Progress Energy

RE: Progress Energy Florida – Levy Nuclear Project Units 1 and 2
DOAH Case No. 08-2727; DEP OGC Case No. 08-1621; PPSA No. PA08-51
DETERMINATION OF INCOMPLETENESS (*Main Site & Associated Facilities)*

Responses to Comments on Levy Nuclear Plant Units 1 and 2 Site Certification Application for Power Plant and Associated Facilities

EXHIBIT 1
Springs Near LNP Site

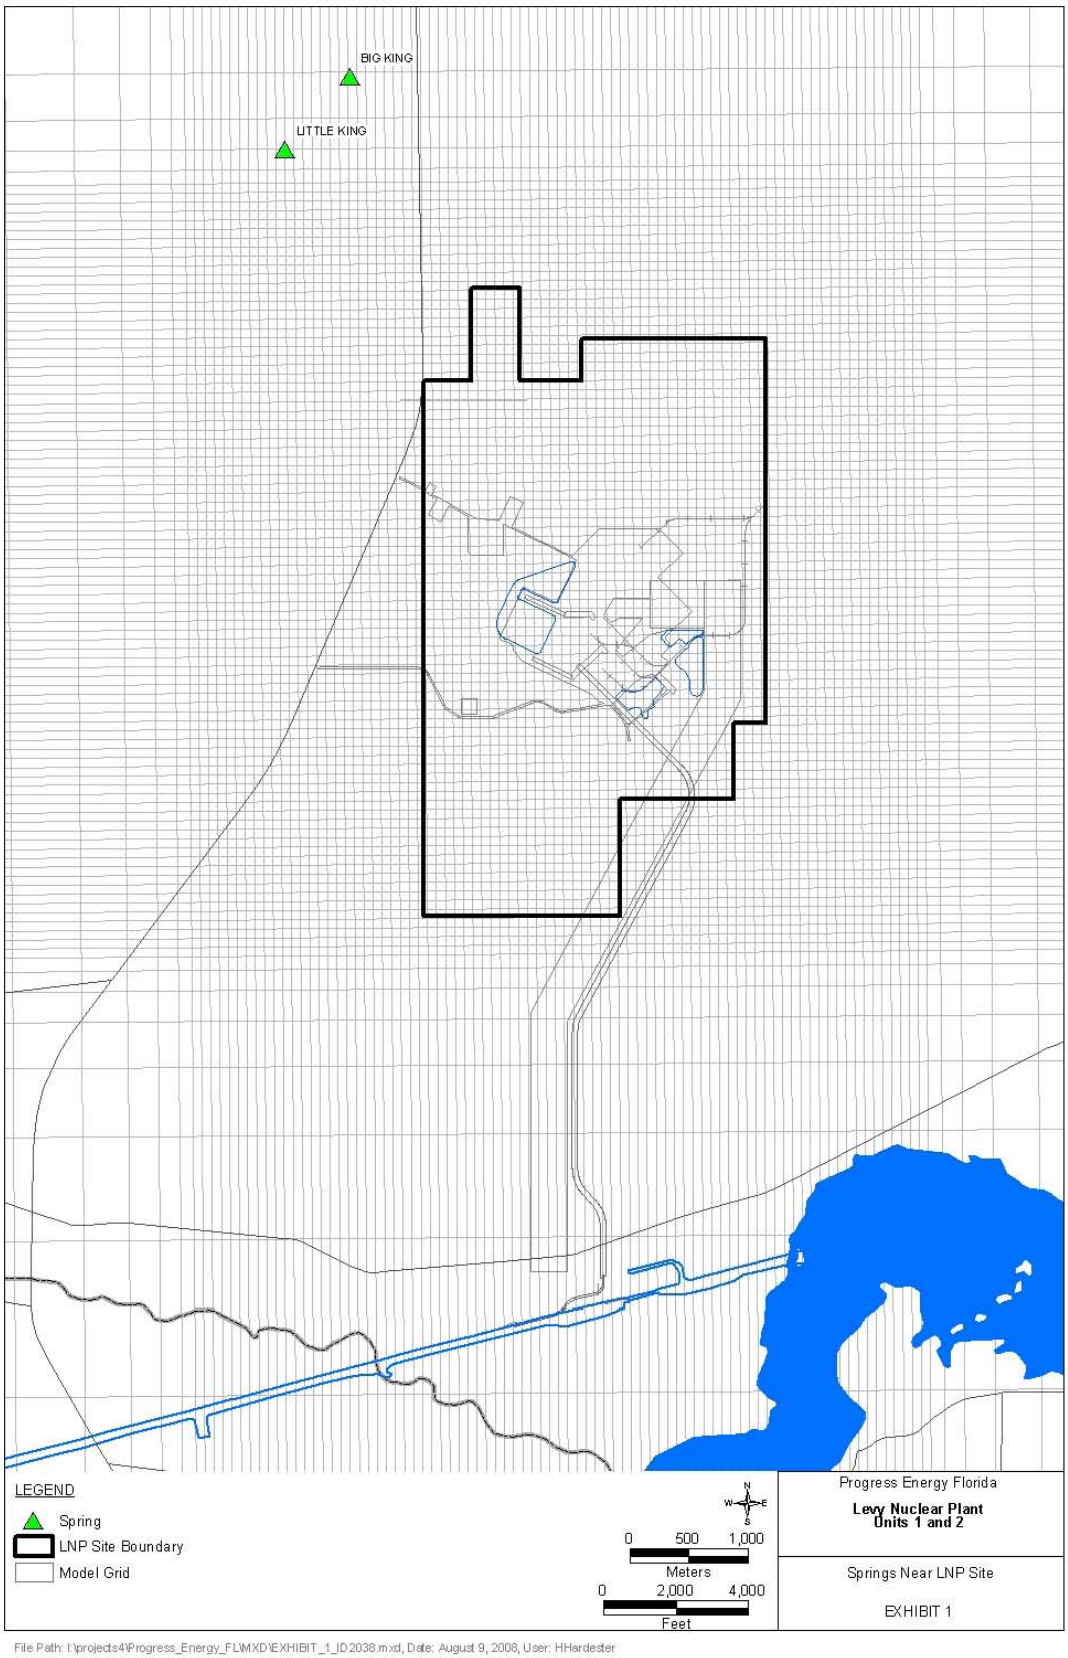
Please provide a scaled location map showing all Class 4 springs, or greater within one-mile of facility property boundary that could be affected by the facility's operations and potential contamination. Figure 2.6-2 shows the Homosassa Springs Dome, and any hydrogeological and chemical issues regarding aquifer connectivity to any springs in the area, and the effects on these springs needs to be addresses.

Exhibit 2 summarizes the details on each spring added to the model.

EXHIBIT 3
Original and Revised Wellfield Layouts

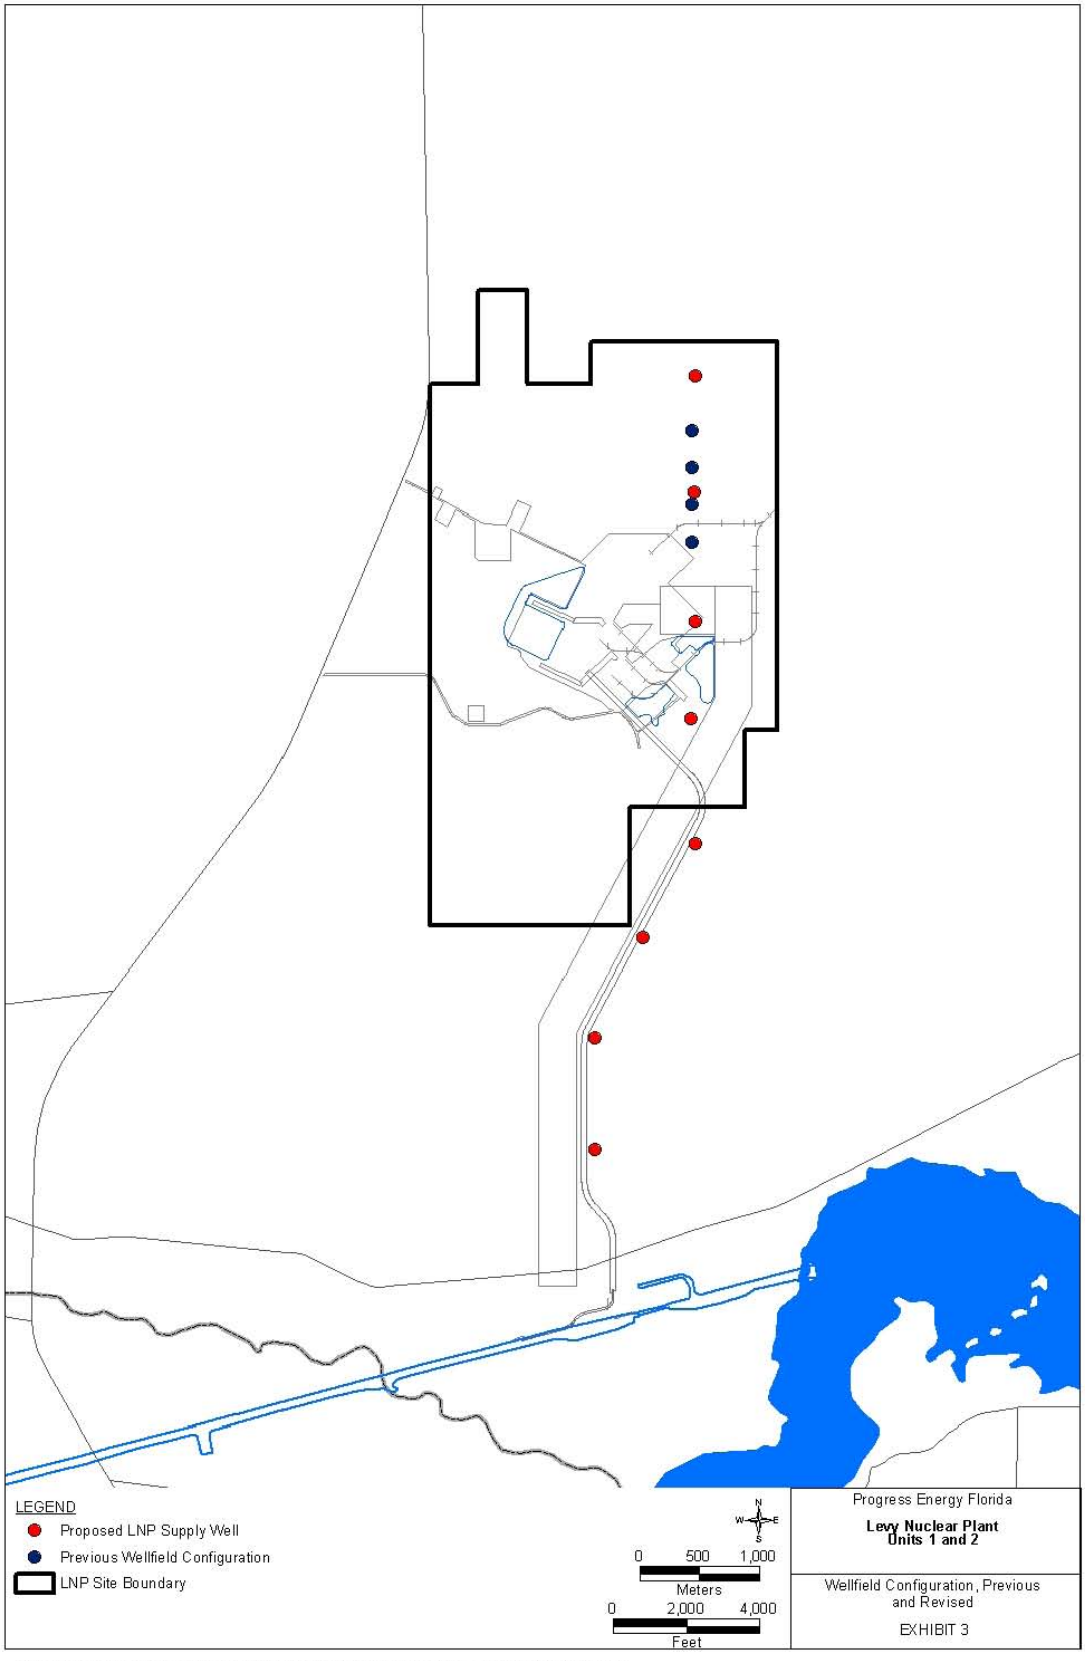
The layout and operation of the proposed wellfield was also modified. The original wellfield layout included 4 wells on 1,000 ft spacing located northeast of the plant. The new conceptual wellfield layout includes eight wells, running in a north-south alignment with approximately 3,000 ft well spacing. The wells are positioned east of the haul road and power transmission corridor south of the main plant, and then to the west of the transmission corridor north of the bend in the haul road. Exhibit 3 depicts the original and revised wellfield layouts.

For this revised conceptual layout and operation, the number of wells was increased from 4 to 8 and the well spacing was increased from 1,000 ft to about 3,000 ft. Using a daily well rotation plan, the potential drawdown impacts in the surficial aquifer are significantly less than those resulting from the original wellfield plan. Exhibit 12 depicts the simulated surficial aquifer drawdown contours and wetlands based on this revised wellfield plan.
